CHANGE ORDER

10

<input checked="" type="checkbox"/> ORDERED BY ENGINEER UNDER SECTION 1-04.4 OF THE STANDARD SPECIFICATIONS. <input type="checkbox"/> CHANGE PROPOSED BY CONTRACTOR	PROJECT IDENTIFICATION PROJECT NAME: 36 th Avenue W & 35 th Avenue W, 164 th St SW to SR 99 PROJECT NUMBER: RC1783, RC1784, RR6337, RR6342, UPI 06-0014 Fed Aid #: STBGUL-2585(001)
CONTRACTOR ENDORSEMENT:	CONTRACTOR: Marshbank Construction, Inc.
<div style="display: flex; justify-content: space-between;"> <div>SIGNATURE</div> <div>DATE</div> </div>	ADDRESS: PO Box 97 3304 Old Hartford Rd Lake Stevens, WA 98258
<div style="text-align: center;">TITLE</div>

This Change Order compensates the Contractor for removing and replacing existing storm drainage pipe runs and catch basins from Station 88+00 to 94+00 and as identified on revised plan sheets DR03 through DR05. Prior to removal, the Contractor shall record existing rim and invert at existing catch basins and reinstall the new storm drainage to match the existing invert elevations and pipe run slopes.

REFERENCE
SHEET NO.
DR04
SHEET
73
OF
163
SHEETS

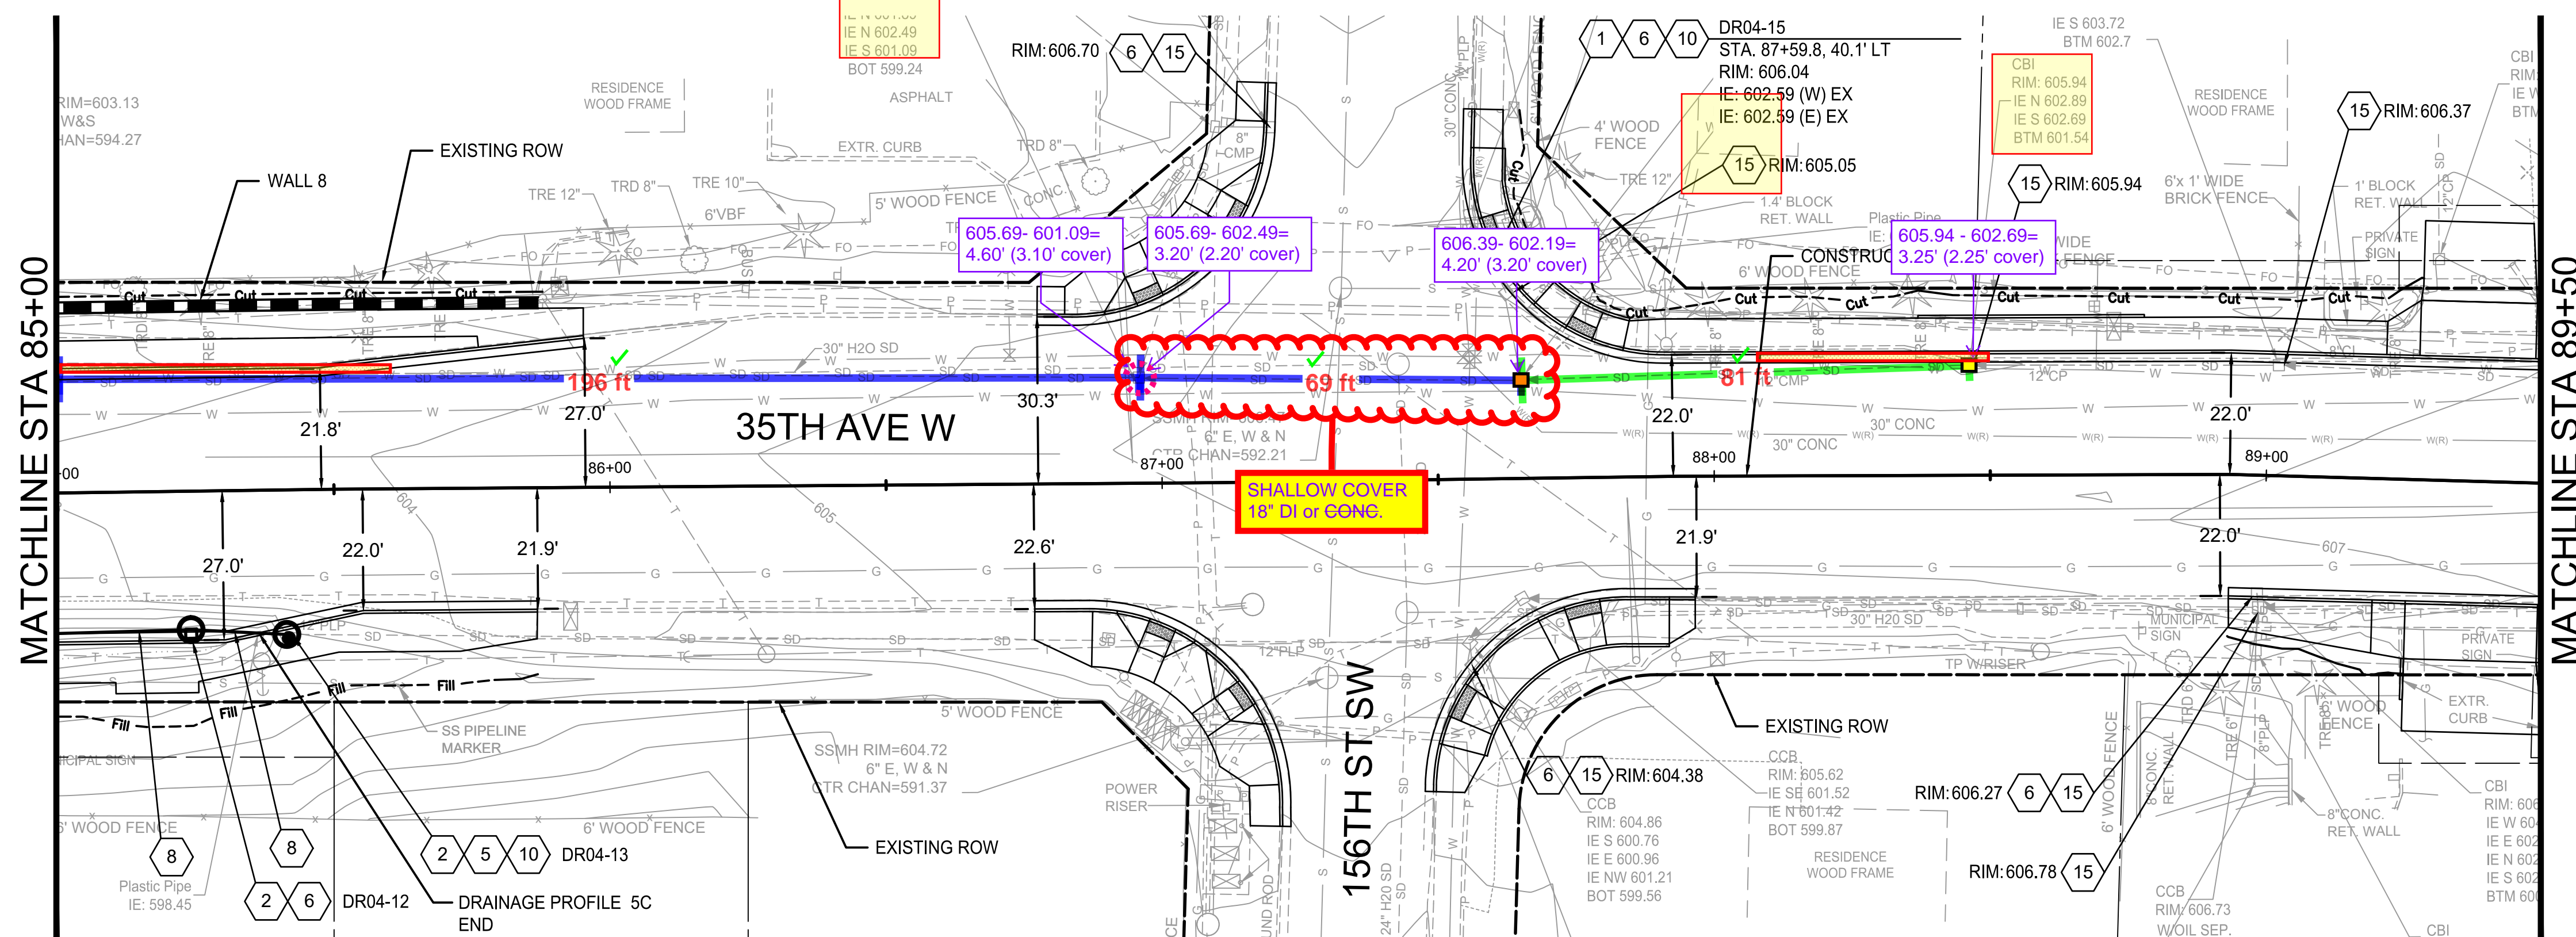
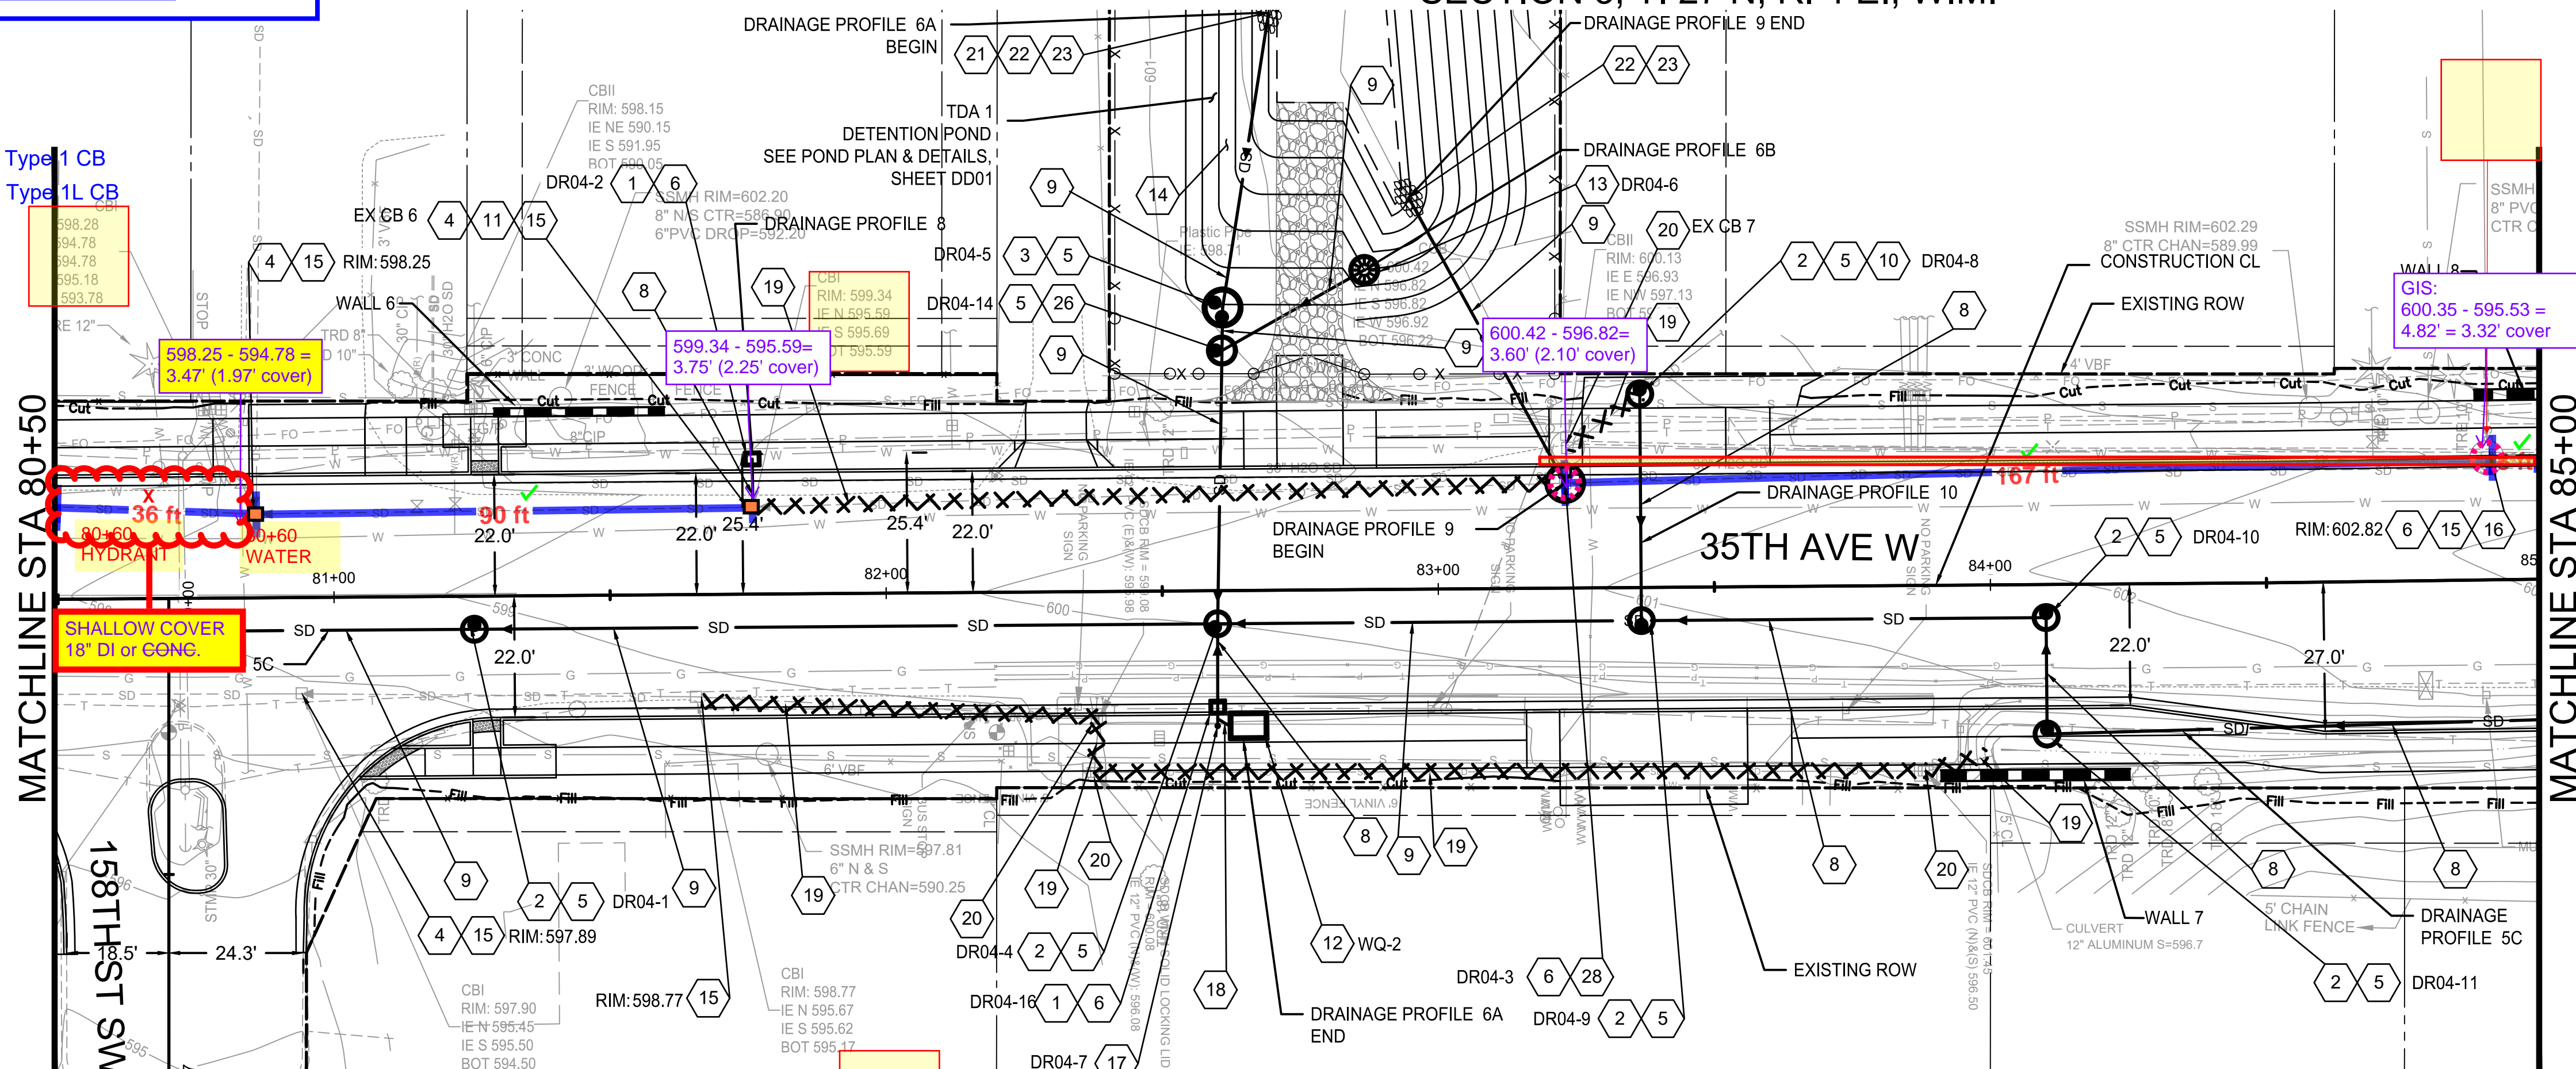
Existing GREEN LINE = 12" CMP

Existing BLUE LINE = 18" CMP

Ductile Replacement

= Replace - Existing Type 1 CB

= Replace - Existing Type 1L CB

MAINTAIN EXISTING ELEVATIONS FOR REPLACEMENT PIPE AND STRUCTURES

Removing Drainage Structure and Removing Existing Pipe includes the removal and disposal of catch basins and storm drain pipes where new catch basins and pipes are shown on the revised plan sheets DR03 through DR05, or where designated by the Engineer.
